Staff Report

Re: PLNPCM2025-00671 - Planned Development
PLNSUB2025-00670 - Preliminary Subdivision Plat

Planned Development/Preliminary Subdivision Plat

PROPERTY ADDRESS: 344 W. 400 N.

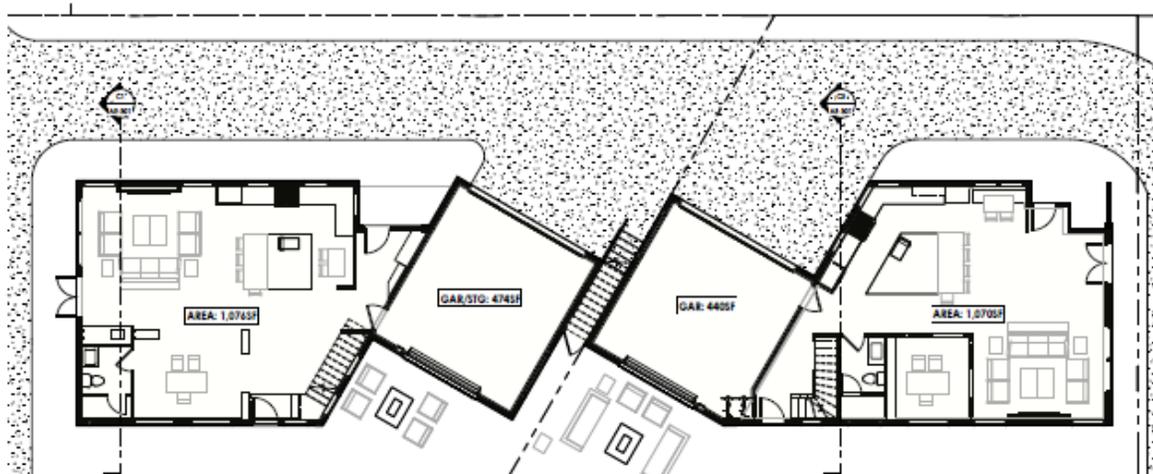
Only Lot 1 has the required lot width along 400 North. In the SG-1 zoning district, twin homes are required to have a minimum of 25' lot width. Although the subject property has frontage along Pugsley Street/Ouray Avenue, it does not meet the minimum amount of 25 feet.

A1 GROUND LEVEL - TWIN HOME - UNITS 'A' & 'B'
SCALE: 1/8" = 1'-0"

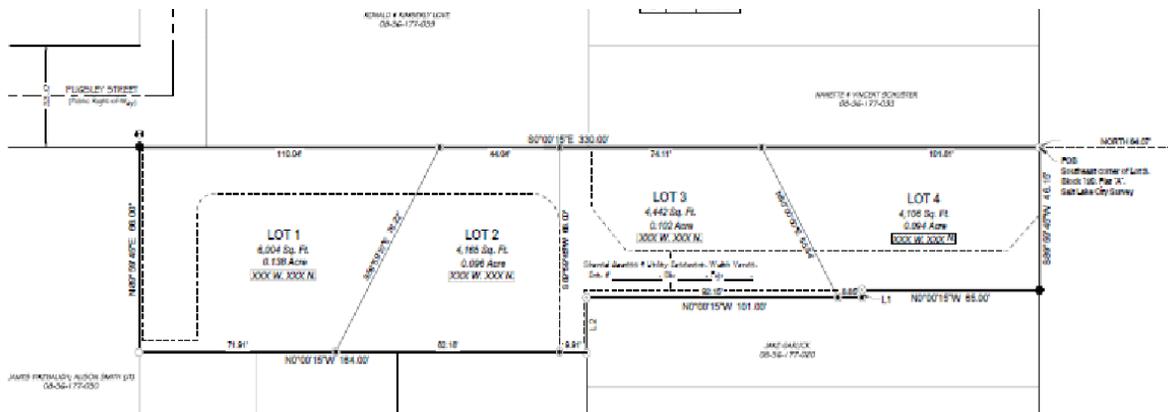
provide a cross-access easement for the ADUs to share the stairs. This must be noted on the final subdivision plat. Planning staff has reviewed the preliminary subdivision plat and finds that it generally meets the approval standards.

Plan showing stairs on one lot: cross-easement needed

- The applicant must note a cross-access easement on the final subdivision plat for any stairs that are shared between two units/lots.

A1 ARCHITECTURAL SITE PLAN
SCALE: 1" = 20'-0"

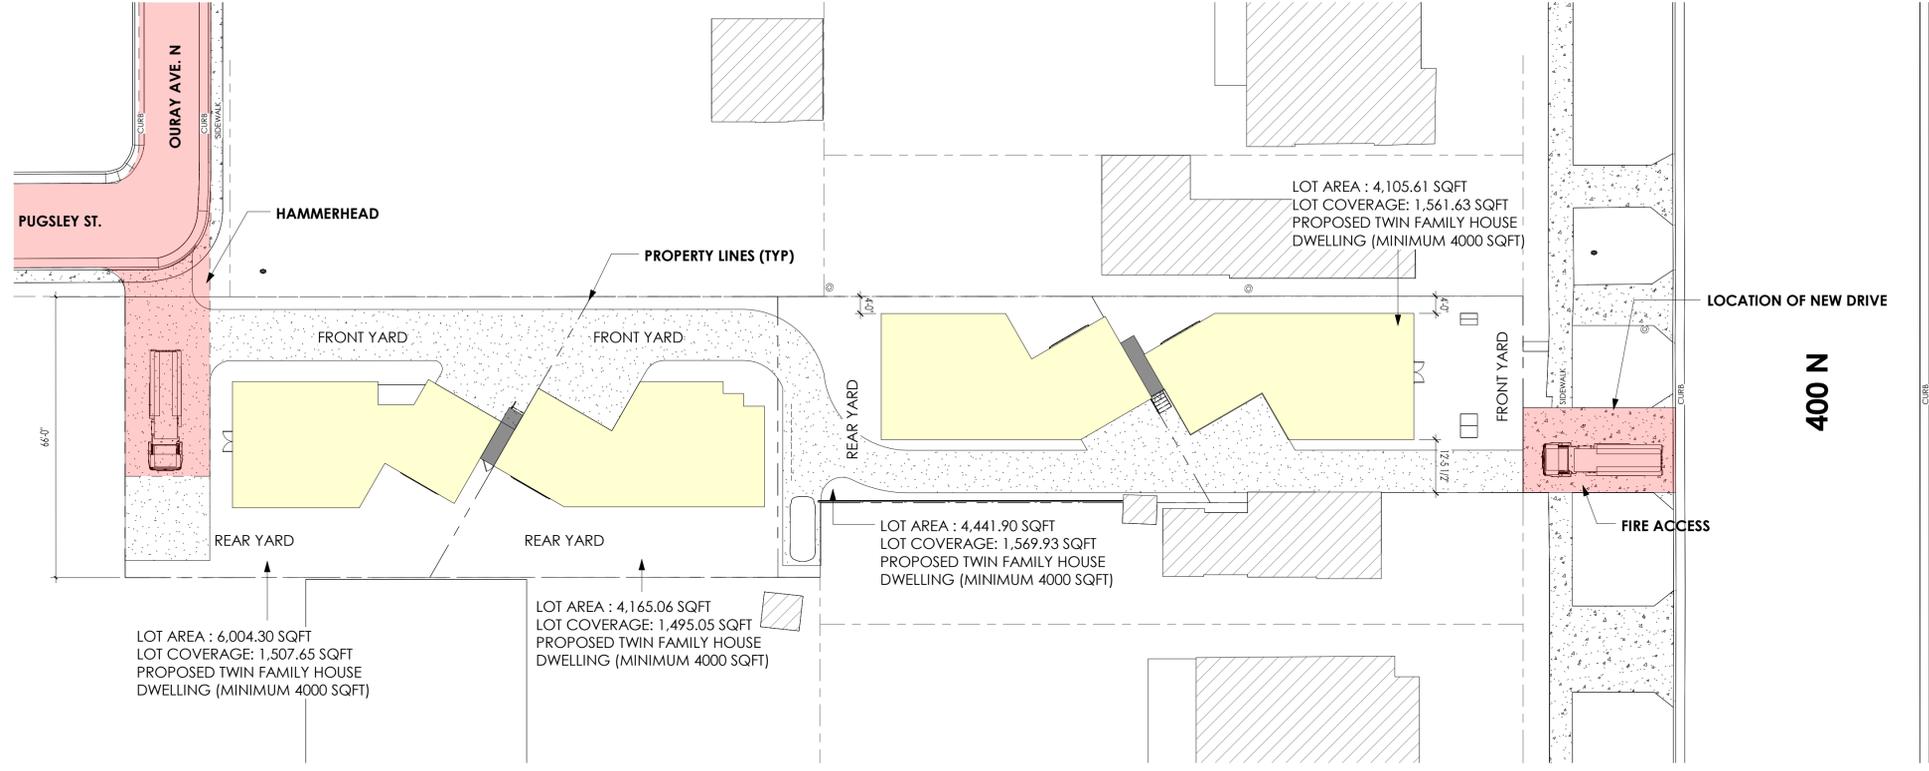
My name is Cortney Anderson and I own/occupy the property at 328/326 W. 400 N. I am writing with concerns over the proposed site development that is two parcels to the west of me. My first question is the setbacks on the proposed site plan. The letter that was sent out via mail was very blurry, but it looks as though there will be very little space between the east property line and the proposed drives. I understand that back when my building was built, the regulations were more lenient in that my drive and my neighbors drive are on the property line. Have these regulations changed? The west set back looks a little bigger, but still seems very close.
